# **XCSAV**

## **CROSS COUNTRY SKIING ASSOCIATION VICTORIA**

### **Update on the Falls Creek XC Stakeholder Forum alternative trail options consultancy**

Alternative trail options proposed.

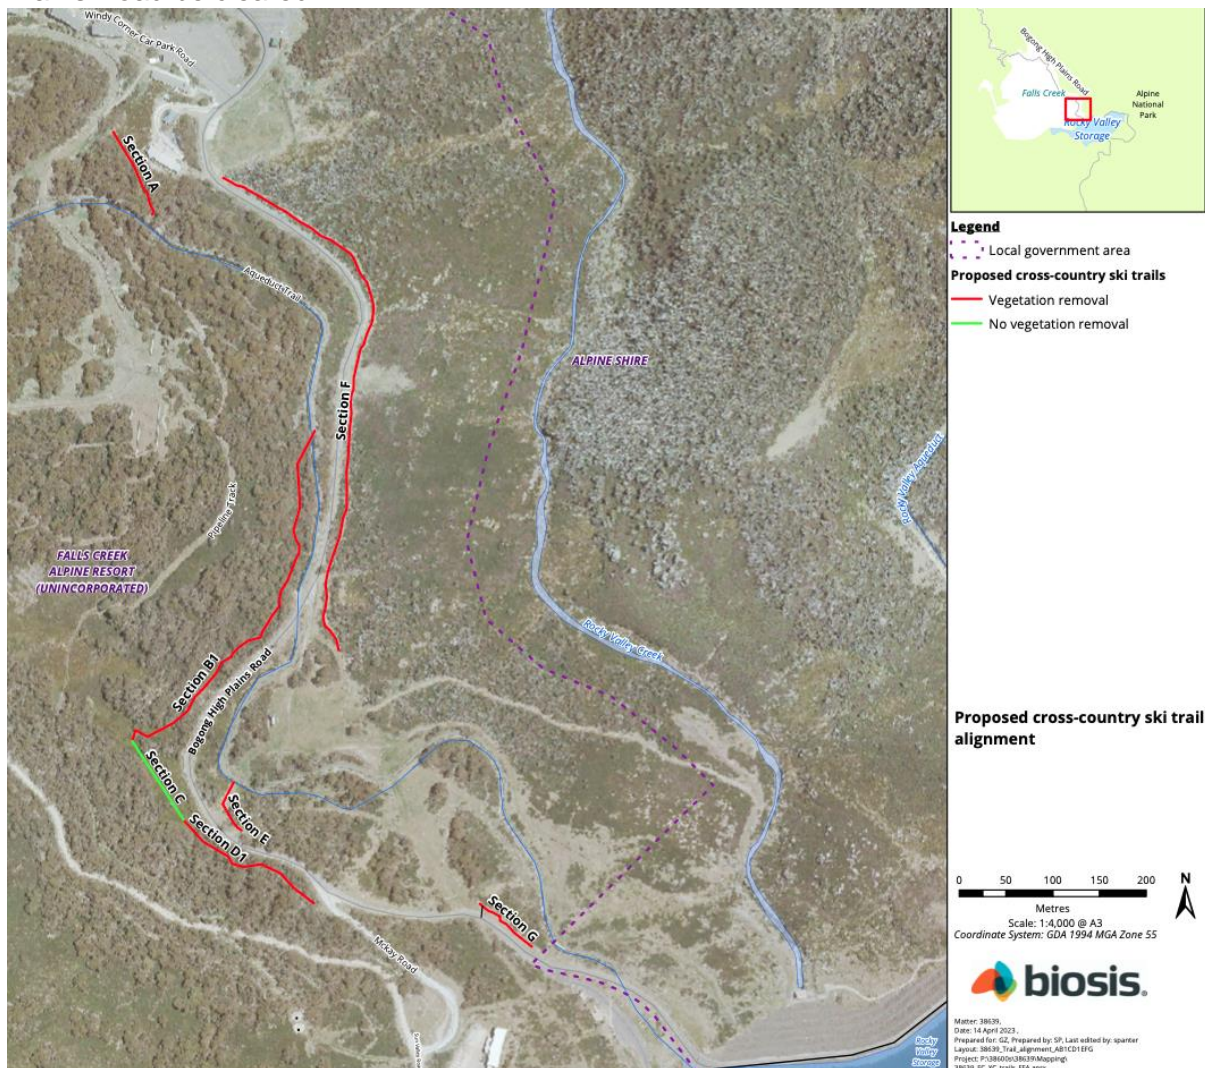
There was concern that Biosis was not given the information on what would be required for the sections to form replacement access and ski trails compared to what is provided by the BHP road.

This was evident in comments from Matt (Biosis Senior Ecologist) at the start, that **Section F** is already an existing MTB trail and that trimming of snow gums, minimal clearing would be required with some widening.

We all commented that the replacement would need to be approximately 6-8 metres wide, not off camber, cleared of heath to enable grooming. We also commented that snow could not be cleared from the road onto ski trails.

**Section A** is proposed to include a staircase, the terrain is quite steep and it would need to have a grassed surface, therefore the existing heath would need to be cleared, to enable use under low snow conditions.

It would need to be at least 6-8 metre wide with no camber. It would also require a significant flat area at both ends of staircase to allow for skiers putting on and off skis and have space for descending skiers to slow down and stop.

**Section A** would not be able to be used by skiers wanting to tow a pulk or by DWA athletes using a sit ski.

**Section B1 C and D1** This area has significant off slope and camber which would need to be addressed.

The comment from Biosis was that while some parts of this section do have powerline access which would make it easier to get approval, the vegetation in the **Section C** in green

is not able to be cleared, so this section will only be useable after very significant snowfalls, rendering the trails B1 and C1 unusable at the beginning and end of the season.

**Section E** seems to be a link from the Horseyards Loop back to the bowl. However, unless the aqueduct has been covered this trail would be impossible. We commented that even with this Link Trail the FIS course required the use of a large section of the BHP road.

**Section F** is parallel to and below the BHP road that will be cleared of snow.

Several issues were raised regarding **Section F**:

- a) Will the earthworks required to create a trail that meets the standard specified have an impact on the stability of the already unstable BHP road above.
- b) How will FCRM ensure contaminated snow cleared from the road not end up on the trail below.

**Section G** relates to the section of the Hoppet course immediately after the start. The start line is 20 metres wide (30 skiers) wide and the first five hundred metres needs to be wide and straight as possible to provide both fair and safe skiing conditions.

The viability of the Hoppet has been discussed with three international FIS Technical Delegates who have experience at the Hoppet and remain unconvinced that the proposed alignment will meet the requirements of a FIS popular race.

Unfortunately, the map provided in the pre meeting information did not give any indication of how the area from the Observation Deck through to the end of the proposed Lakeside development will be managed to provide the essential two separate Hoppet tracks, one out into Sun Valley and a return trail closer to the lake.

*Mud map provided at the meeting*

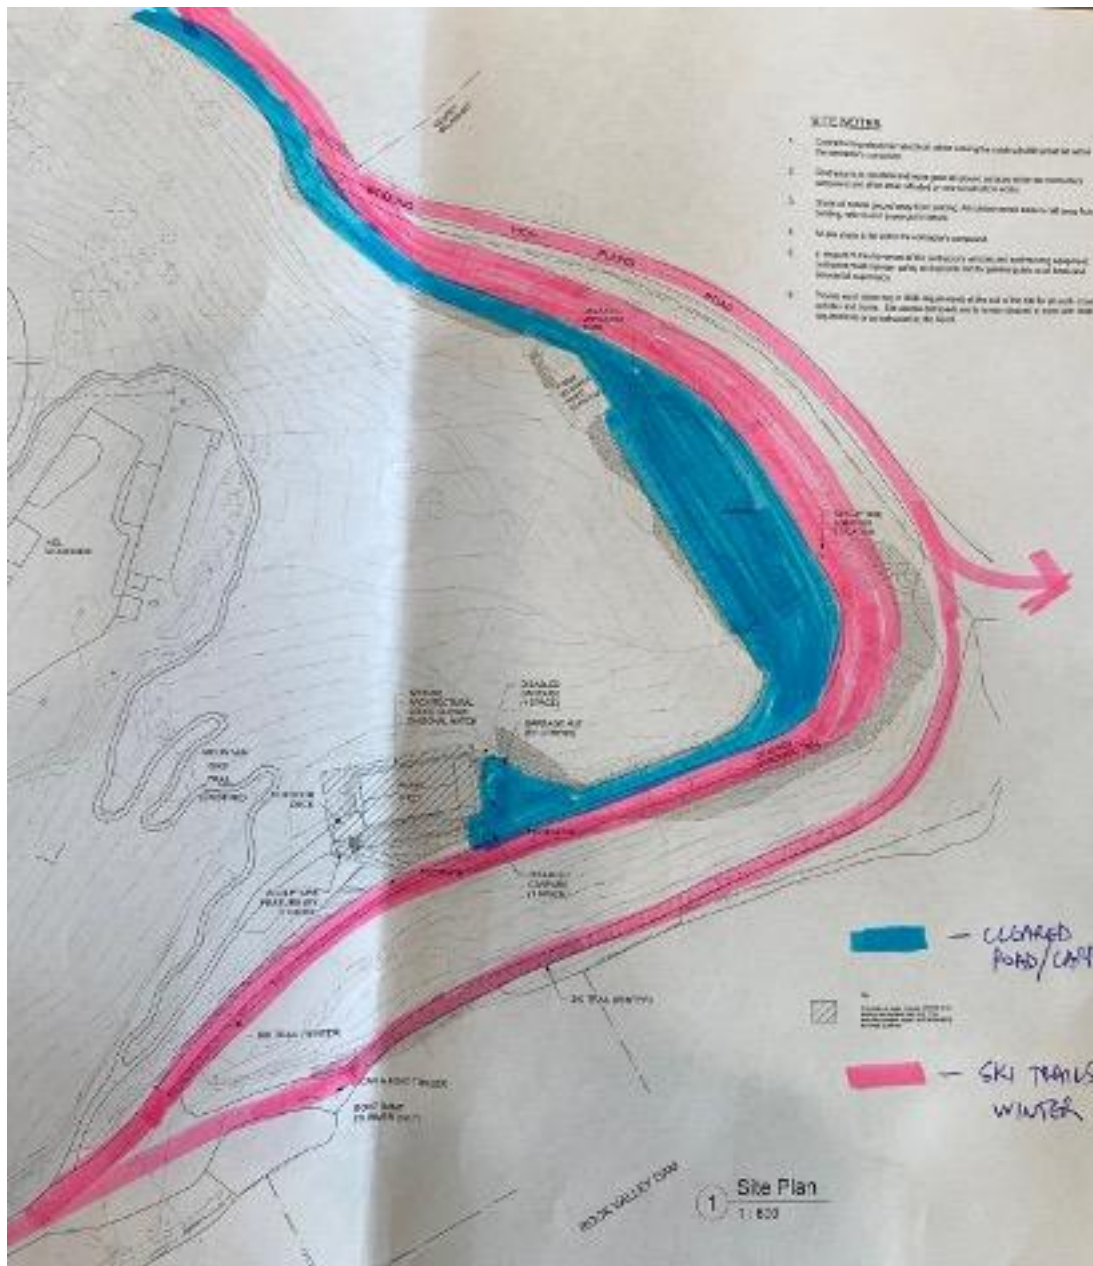
1. Lack of knowledge about the Bog in front of the ANARE shed which should not be benched over.
2. We were told that coach buses could drop off at the car park, but there does not seem to be a turning circle to accommodate this on the mud map.
3. The exposed and windy nature of lakeside
